**SECTION ONE**  
**INTRODUCTION**

**SUMMARY OF DRAFT  
ENVIRONMENTAL IMPACT REPORT**

## **SECTION THREE – COMMENTS AND RESPONSES**

### **3.2 Responses to Comments**

PERCOLATION POND CONFIGURATION

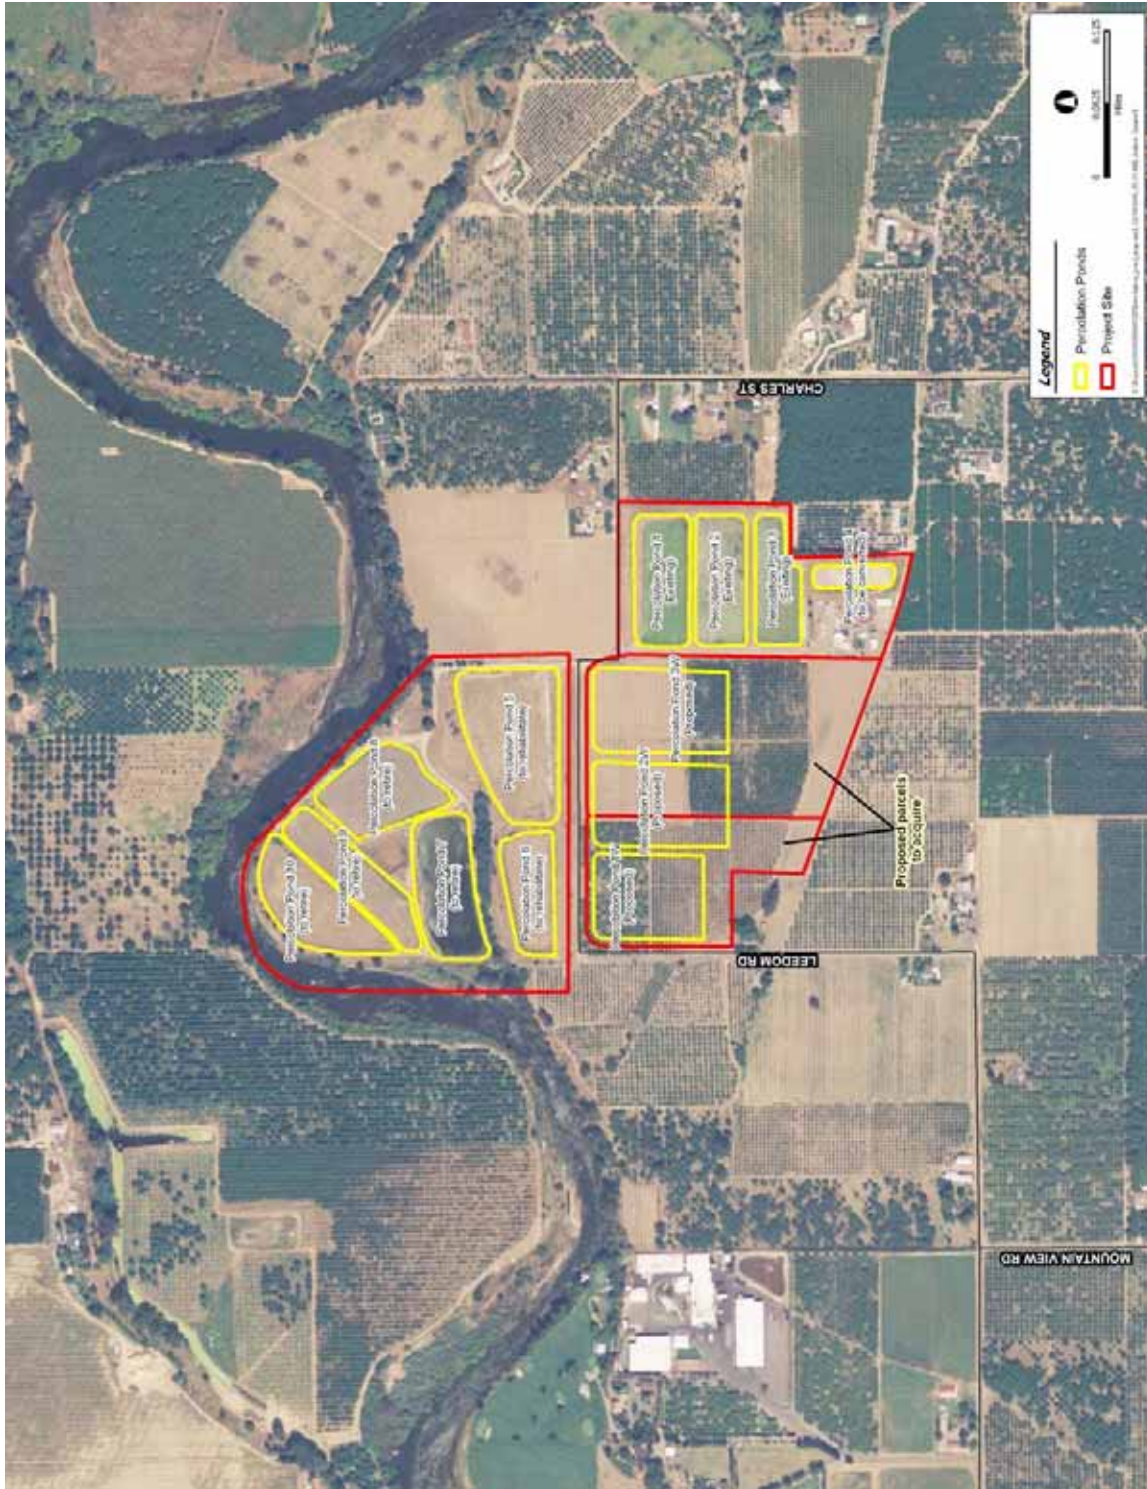
Ponds 7, 8, 9, and 10 will be taken out of service. No treated wastewater will be sent to them. There are no plans to physically alter the existing ponds. Due to their location in the 100-year flood plain, these ponds could not be used for stormwater retention.

*"If the City of Hughson WWTP plans to continue utilizing percolation ponds 5 and 6 for water disposal, please provide full disclosure of the current seepage problems associated with their lower berms. Additionally, please describe the investigative and/or rehabilitation techniques that will be needed to fix the current conditions.*

The City does not use ponds 5 and 6 for disposal, nor do they have plans to do so. The use of ponds 5 and 6 was discussed as an option, if and only if, they could be rehabilitated. The final pond layout shown in the Master Plan does not require the use of ponds 5 and 6 at this time to
